Re: Dreamstyle Warehouse
1525 Renaissance Blvd NE
Traffic Circulation Layout
Engineer's/Architect's Stamp dated 6-30-15 (F16-D051A)

Re: **Dreamstyle Warehouse**
1525 Renaissance Blvd NE
Traffic Circulation Layout
Engineer's/Architect's Stamp dated 5-12-15 (F16-D051A)

Based upon the information provided in your submittal received 5-19-15, the above referenced plan cannot be approved for Building Permit until the following comments are addressed:

DREAMSTYLE WAREHOUSE
SITE DETAILS
ALBUQUERQUE, NM
PROJECT #1465

C1 HC PARKING SIGNAGE ELEVATIONS 3/4"=1'-0"

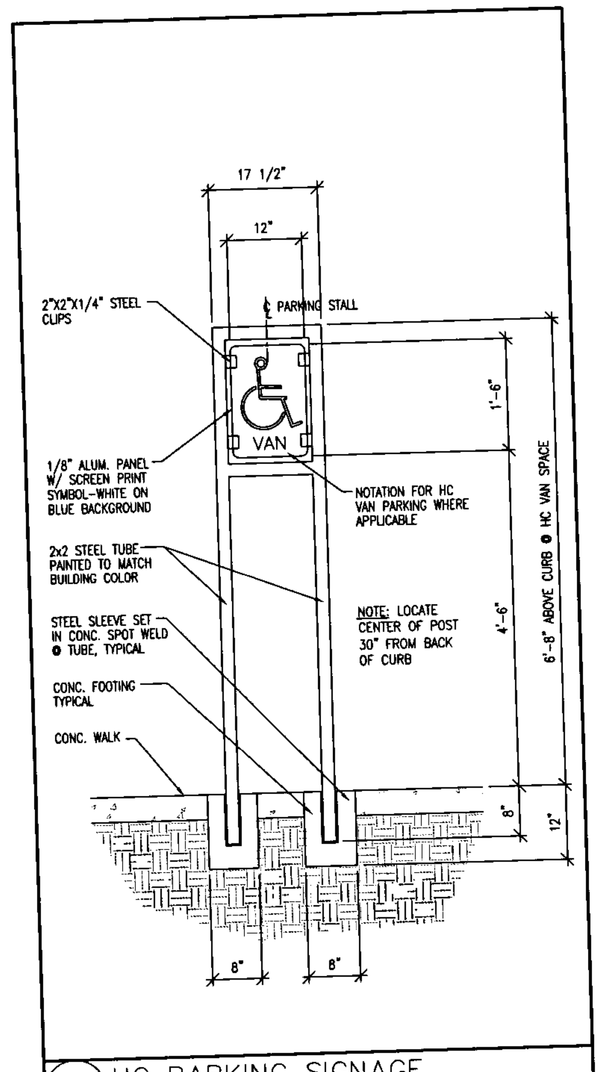
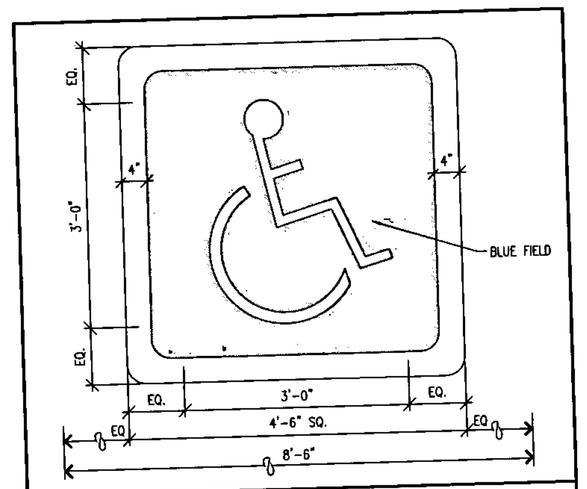
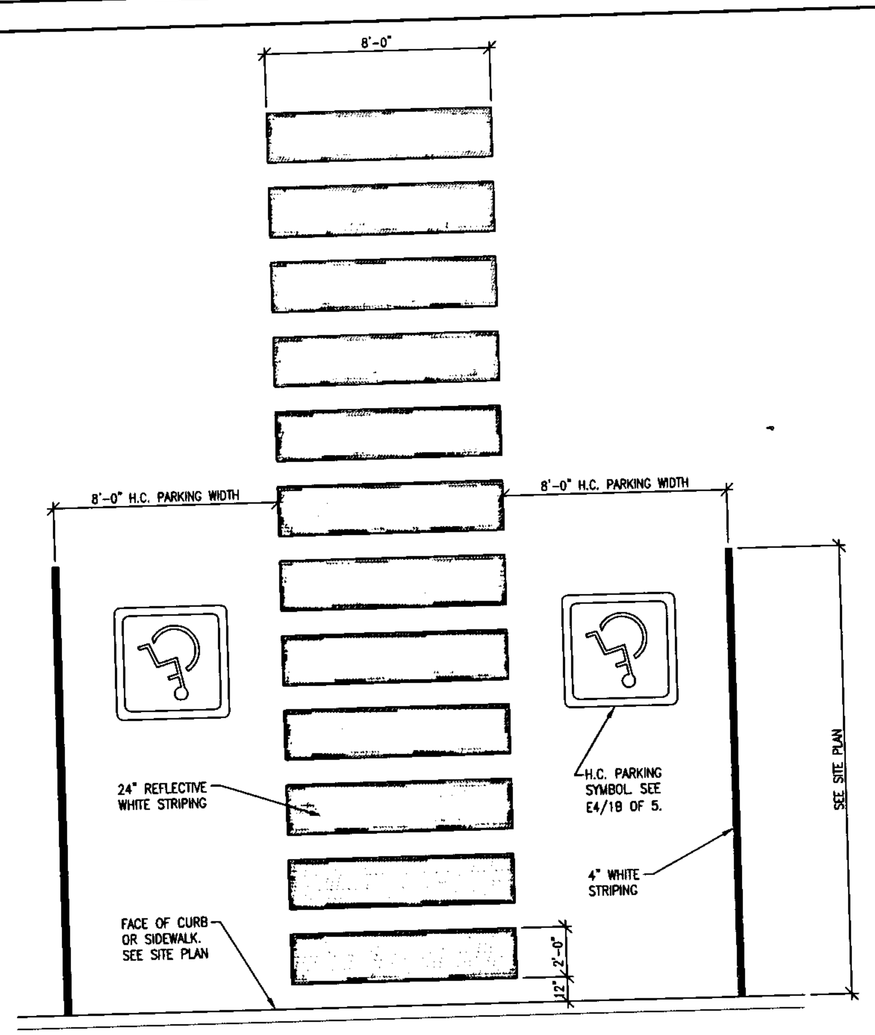
3. Please identify and detail the bicycle rack.
4. The handicap accessible spaces must be a minimum of 8.5 feet in width.
5. The handicap accessible spaces must include an 8-foot wide van access aisle; all other aisles should be 5 feet in width.

6. The ADA van accessible sign must have the required language per 66-7-352.4C NMSA 1978 **"Violators Are Subject to a Fine and/or Towing."**
7. The ADA access aisle shall have the words **"NO PARKING"** in capital letters, each of which shall be at least one foot high and at least two inches wide, placed at the rear of the parking space so as to be close to where an adjacent vehicle's rear tire would be placed. (66-1-4.1.B NMSA 1978)

C3 HANDICAP RAMP ISOMETRIC N.T.S.

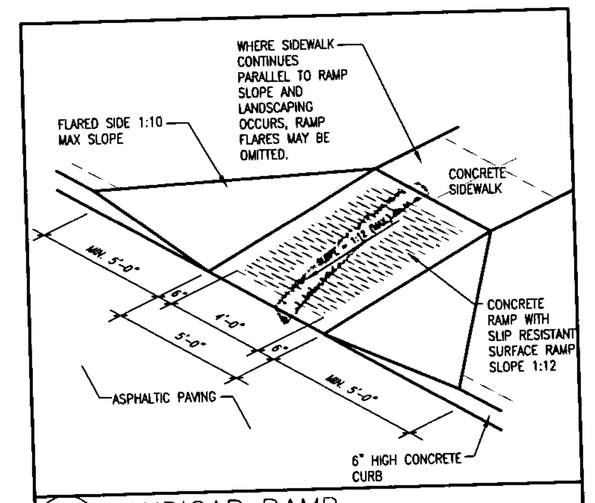
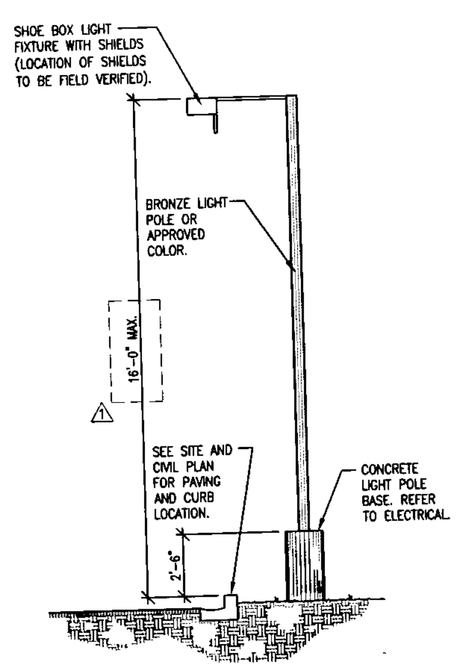
8. Please detail the Private Entrance off of Renaissance Blvd, per COA Standard Drawing No. 2426. Detail ADA ramps with truncated domes from public sidewalk to pedestrian walkway entrance to proposed building.
